**CITY OF SUWANEE  
VARIANCE ANALYSIS**

**CASE NUMBERS:** V-2019-014 and V-2019-015

**REQUESTS:** STREAM BUFFER ENCROACHMENT

<b>EXHIBIT A</b> TITLE: STREAM BUFFER IMPACTS SUWANEE VILLAGE SUWANEE, GWINNETT COUNTY, GEORGIA	PROJECT NO: PLKSH-18-GA-02752-01 REVISIONS: 8-6-19	CLIENT: POLLACK SHORES REAL ESTATE GROUP
	DATE: 7-17-19 CHECKED: MGA PREPARED: VPV SCALE: 1" = 100'

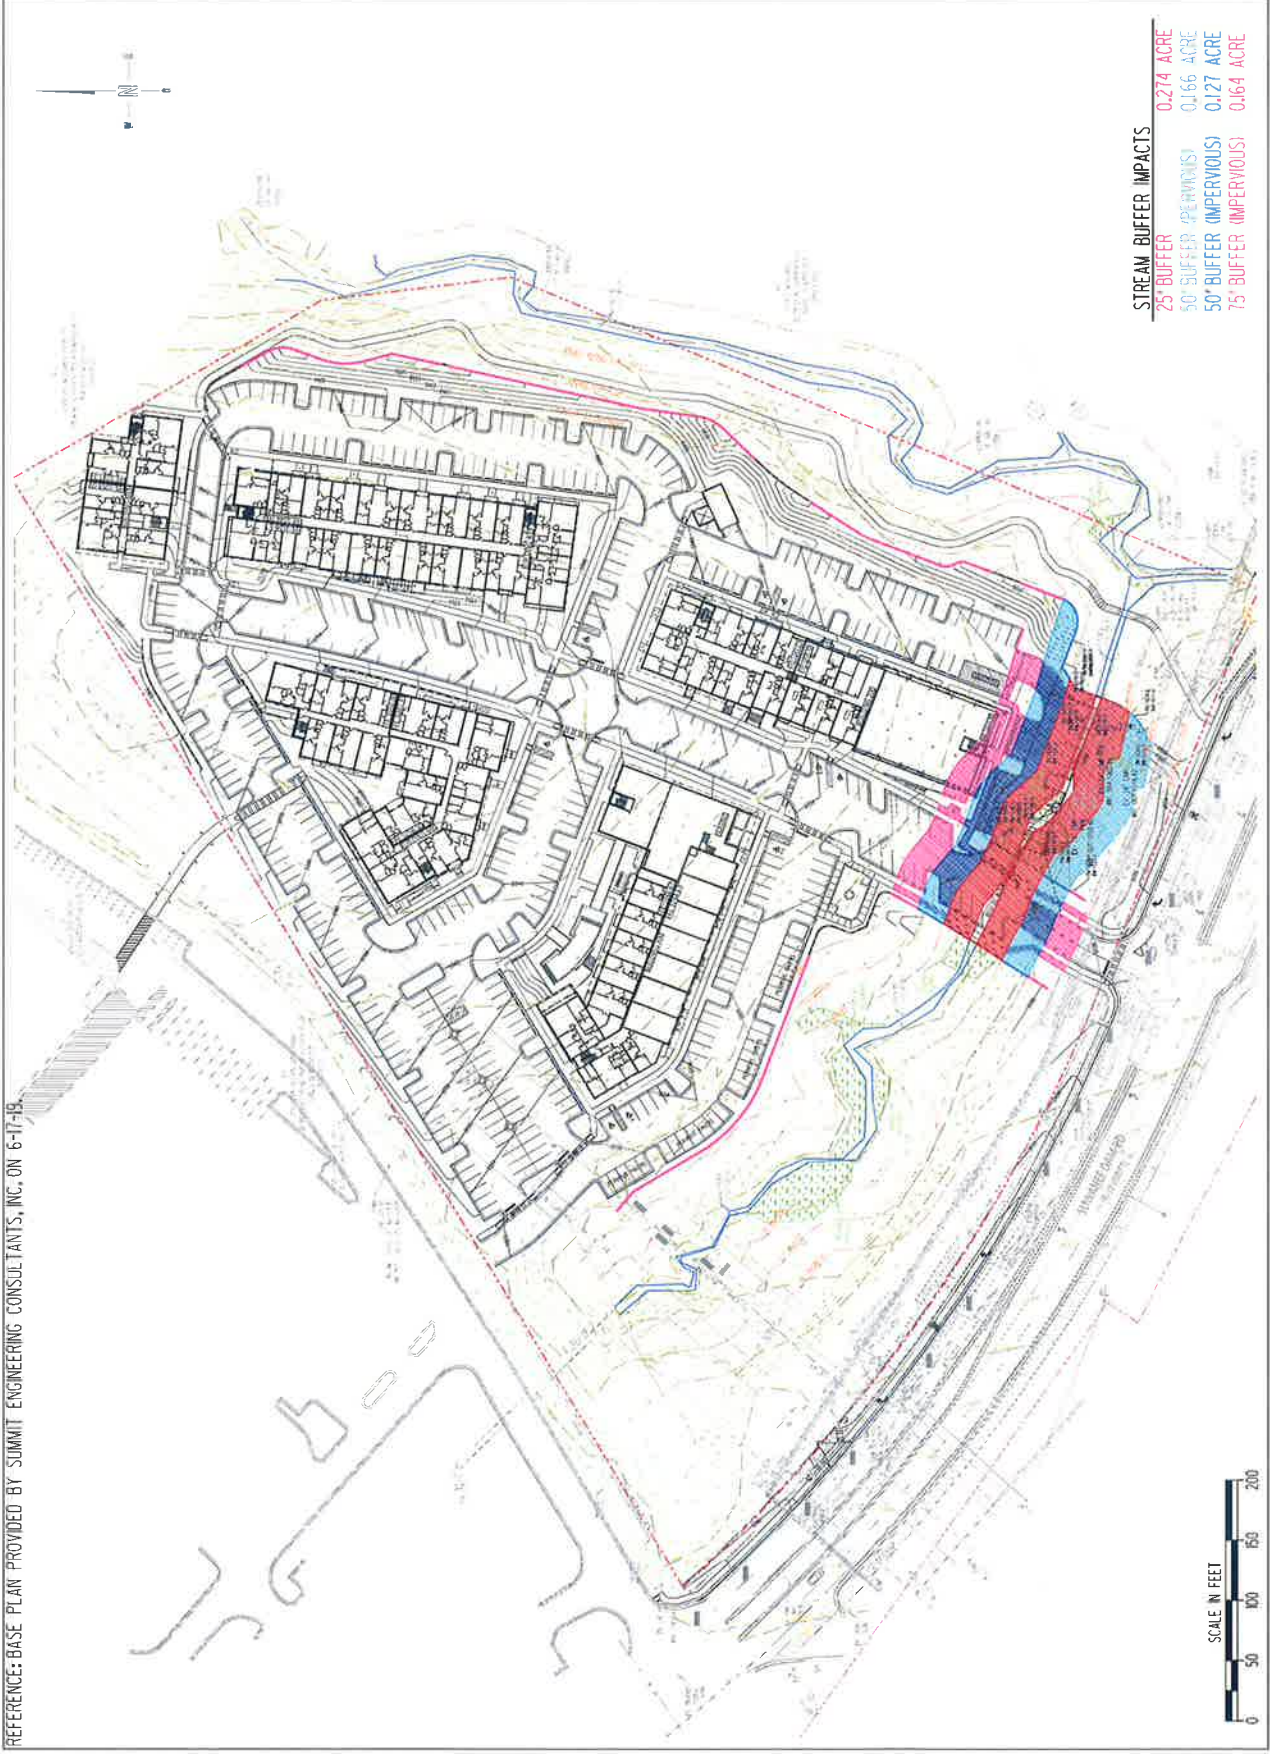
stream shown in “Exhibit A” to eliminate required buffers at the eastern end of the stream. If granted, this request would allow for the piping of approximately 200 linear feet of the subject stream to allow for grading and development of a small portion of one of the buildings and some of the parking, roads and sidewalks within the required buffer around the eastern end of the subject stream. The total buffer disturbance includes .274 acre of the 25-foot buffer, .293 acre of the 50-foot buffer, and .164 acre of the 75-foot impervious setback.

1. The limits of disturbance within the stream and required stream buffers shall be generally consistent with the areas indicated in "Exhibit A."

1. Comply with any conditions of approval associated with approvals from the state Environmental Protection Division and the United States Army Corp of Engineers, as applicable.
2. The limits of disturbance within the stream and required stream buffers shall be generally consistent with the areas indicated in "Exhibit A."
